DEVELOPMENT REVIEW BOARD
SUPPLEMENTAL SUBMITTAL

PROJECT NO. PR-2019-002411

SUBMITTAL DESCRIPTION: Response to comments including a utility plan with a cross section of trench prisms.

**Development Review Board (DRB)
 Review Comments
 Utility Development Section
 Reviewer: David G. Gutierrez, P.E.
 Phone: 505.289.3307**

CONCEPTUAL MASTER UTILITY PLAN

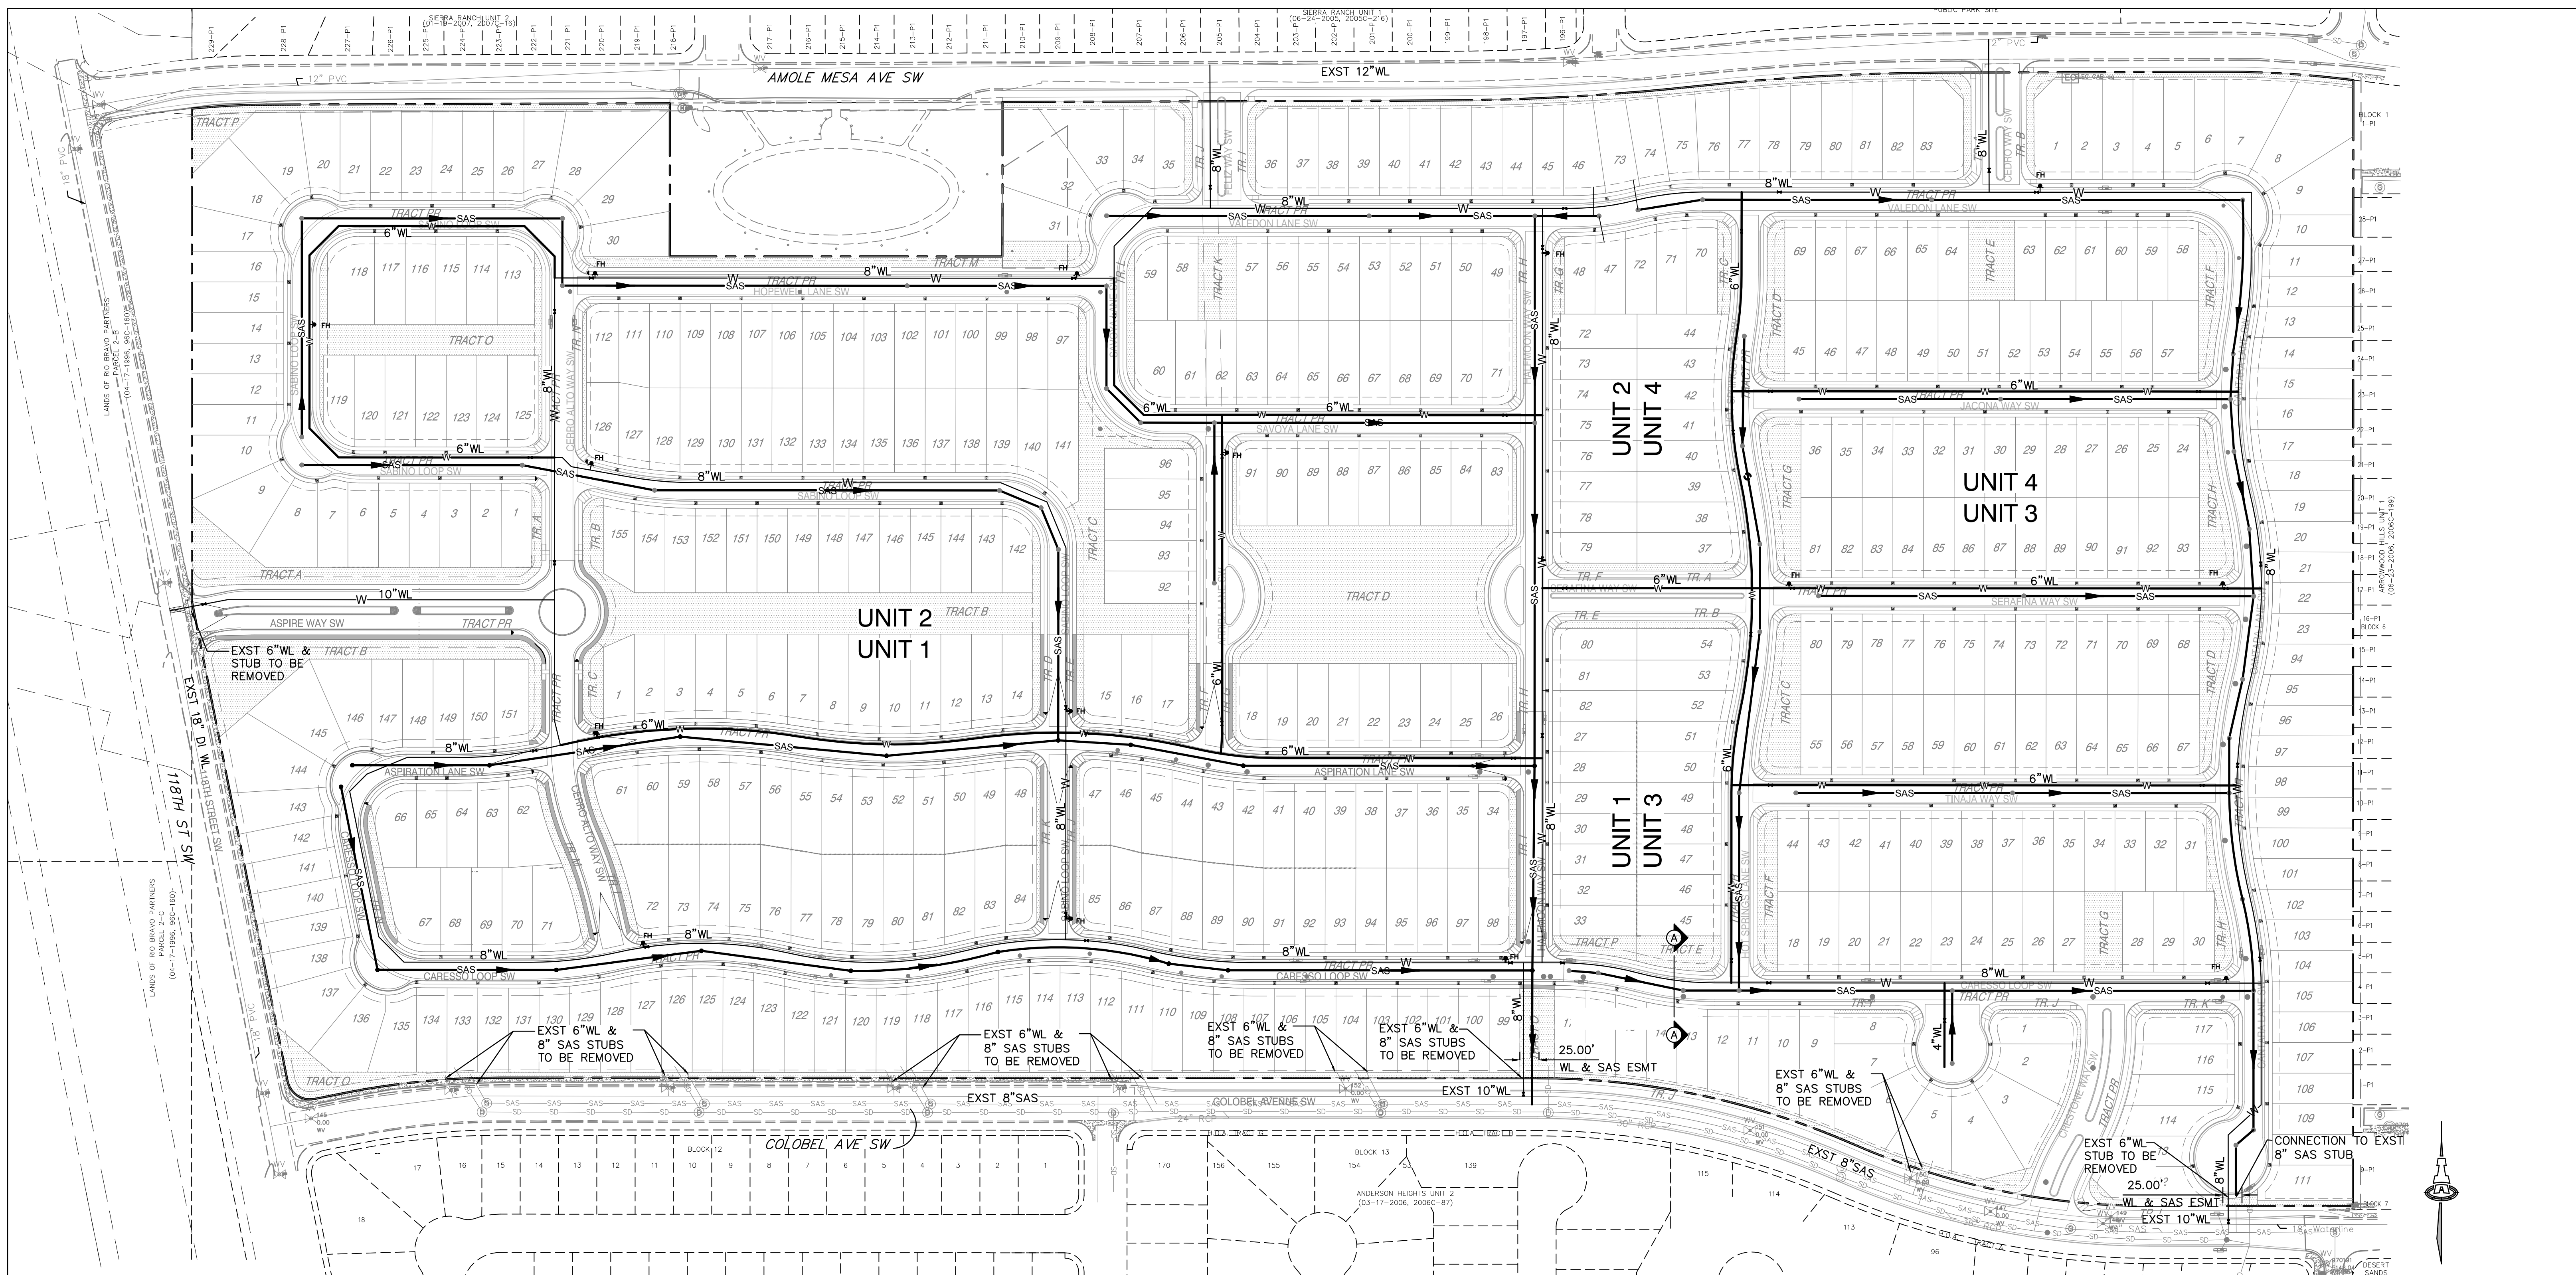
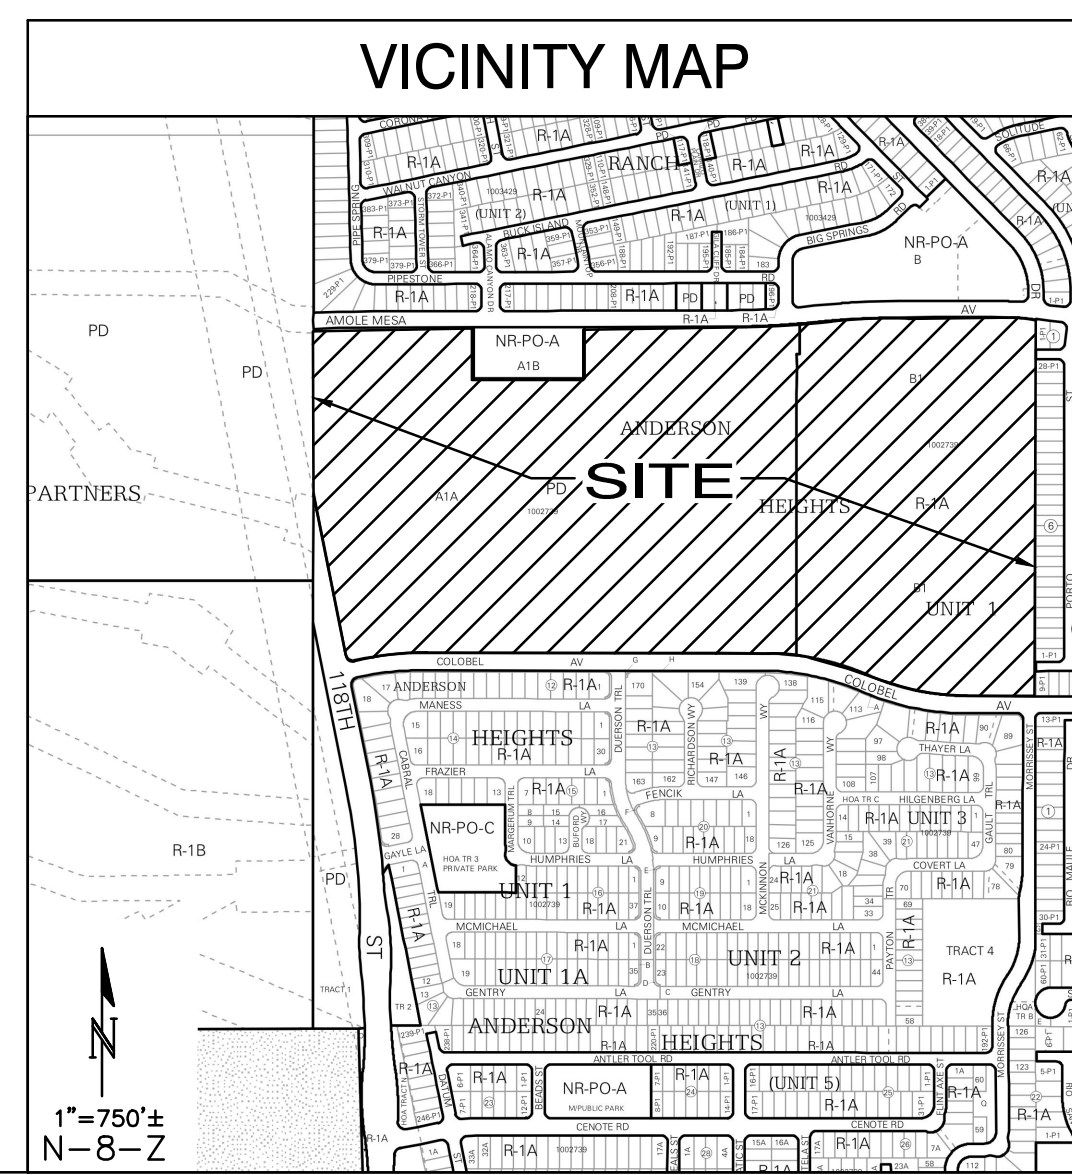
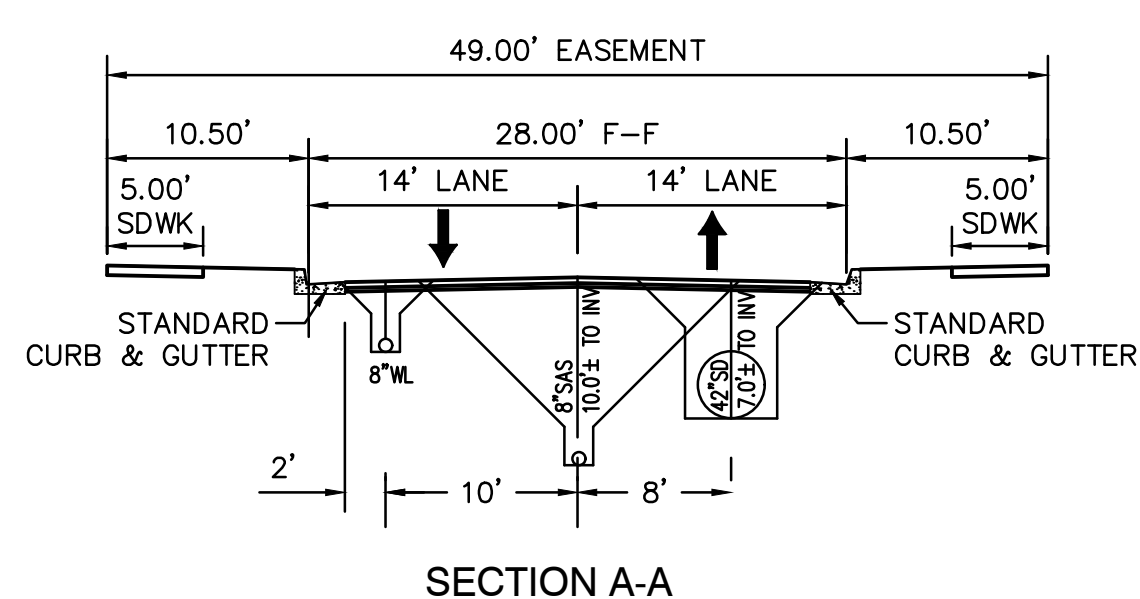
- c. PREVIOUS COMMENT: The preliminary plat did not indicate the maintenance and responsibility of proposed Tract O.
- d. Utility Plan – an updated utility plan was not provided. **See attached plan including cross section A-A for trench prism.**

- iv. PREVIOUS COMMENT: The utility plan does not label 6” waterline that is included on the infrastructure list.
- e. A utility cross section was provided which is presumably for one of the roadway width waivers. This was for Caresson Loop which included an 8” waterline, 8” sanitary sewer and a 42” storm drain. Given the diameters of both the sanitary sewer and storm drain, the actual clearance between the sanitary sewer and the storm drain is less than 6’ outside to outside. Does the cross section consider depths? These aren’t dimensioned. **A new cross section is provided on the attached utility plan. The overlap of the trench prisms at the top by the street are unavoidable in a residential street for deep sewer and storm drain lines.**

- 12. **VA-2020-00164 - RDWAY WITDTH WAIVER(C)**
 - a. Will the narrower width allow for required clearances between all underground utilities?
Storm drain was not shown on the previously provided utility plan. **Yes. See Cross Section Exhibit on the attached utility plan.**
